HISTORIC AND DESIGN REVIEW COMMISSION

HDRC CASE NO: 2016-228

ADDRESS: 924 DAWSON ST

TYPE OF WORK: Reconstruction of front porch

North E	levation Ne	W
Project number	101	
Date	June 30, 2016	A3.2
Drawn by	Author	7 (012
Checked by	Chacker	Scale 1/4" = 1'-0"

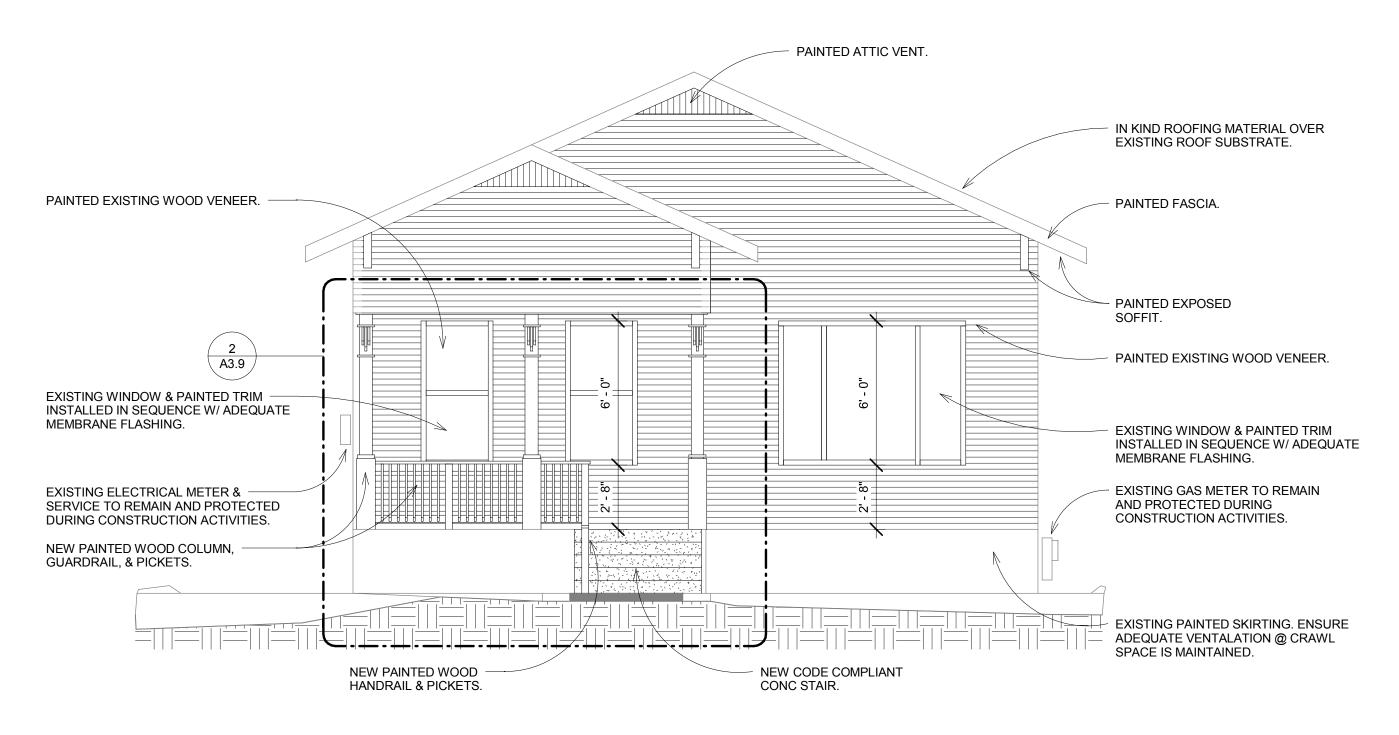
- e. The applicant has proposed three front porch columns that are to feature bases of approximately 9 inches in width, mid sections of 6 inches in width and capitals of 6 inches in width featuring craftsman ornamentation. The applicant's proposal of three columns on the front façade is inappropriate; two columns are architecturally appropriate. The applicant's proposal of ornate craftsman capitals is also inappropriate. Staff finds that the applicant should install the proposed columns at the corners of the porch without the ornate capitals.

- f. Historic houses in San Antonio often feature a vernacular entrance and ventilation system comprised of two front doors; one facing the street and one facing the side yard. The applicant has proposed to reintroduce the front porch door facing the side yard, but no the door facing the street. Staff finds this inappropriate and recommends the applicant install both doors. The door which faces the street should be reinstalled at its original location, centered on the front porch steps.

- g. The applicant has proposed to install two windows beneath the front porch overhang. One window spaced evenly between the end of the porch and the street facing front door, which is to be centered on the front porch steps, is appropriate. Staff recommends the applicant install the window in this manner. This window should be inset within the wall at least two (2) inches or at a depth that is consistent with all other windows.

- i. That the applicant eliminate the craftsman ornamentation from the porch columns and eliminate the proposed middle column as noted in finding e.
- ii. That the applicant reintroduce the street facing front door that is to be centered on the front porch steps as noted in finding f.
- iii. That the applicant reintroduce a front window that is appropriately spaced between the end of the porch and the reintroduced street facing front door as noted in finding g.
- iv. That the applicant pour new front porch steps that maintain the width of the original front porch steps as noted in finding h.
